Rezoning Transportation Analysis

Petition Number	2016-016	Updated	1/29/2016	
Location	Approximately 4.3 acres located on the northwest corner at the intersection of North Davidson and East 26th Street			
Staff Resource	Rick Grochoske	rgrochoske@	<u>charlottenc.gov</u>	704.432.1556

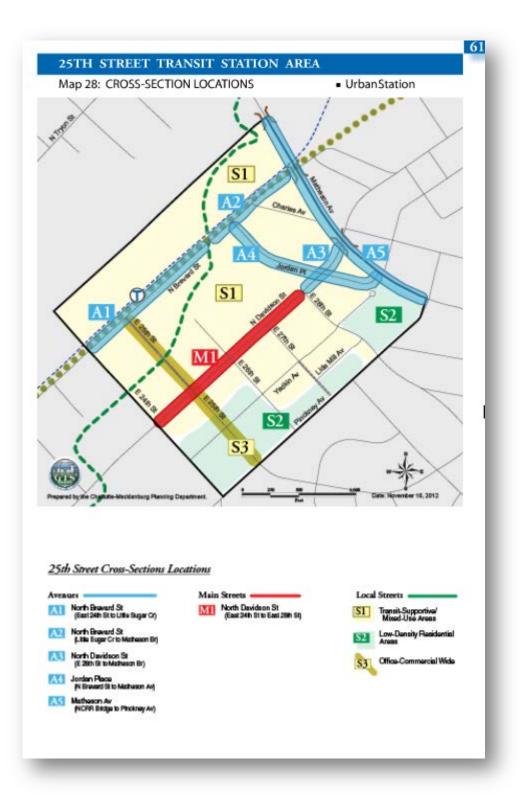
- 1. CDOT has resented the below comment due to a land swap for dedicated right-of-way and construction of the proposed XCT by the petitioner: The Petitioner needs to revise the site plan to depict an east/west street connection through the site to connect to 26th Street and a future street stub from Jordan Place required by petition 2015-51 (See below exhibit). We recommend the petitioner provide more detailed information regarding the site's proposed land use(s) so that the future street connection can be properly sized, to include on-street recessed parking. Without further information the east/west street connection through the site should be a Local Office/Commercial Wide typical street section (See CLDSM U-05A). This East/West Street connection needs to be implemented and platted before the site's first building's CO is issued.

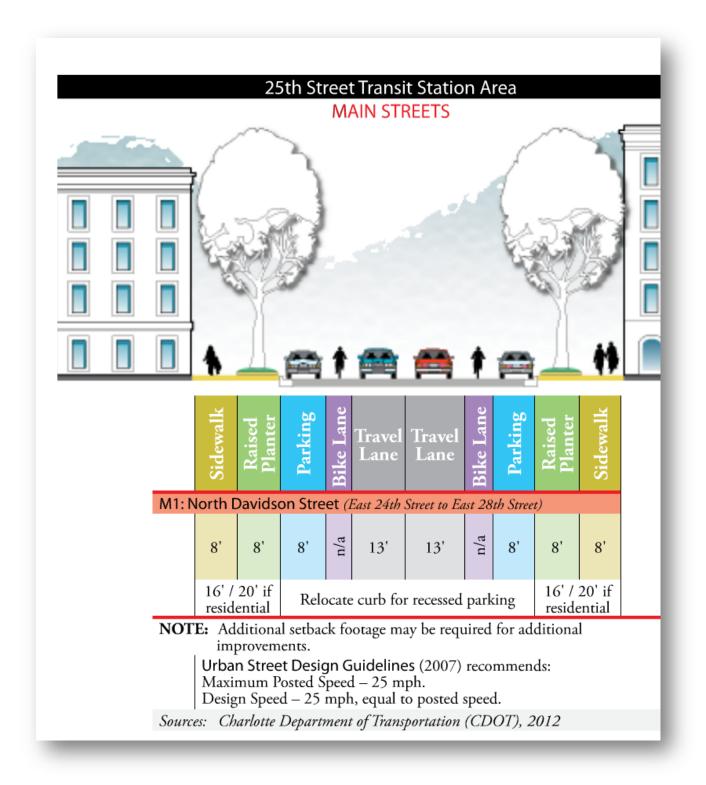
- 2. The Petitioner needs to revise the site plan to depict and reserve right-of-way for the planned Cross Charlotte trail (XCLT) project. The City's XCLT team has recently reviewed the trail's proposed alignment and right-of-way needs with the petitioner/developer (see below exhibit showing XCLT proposed alignment).
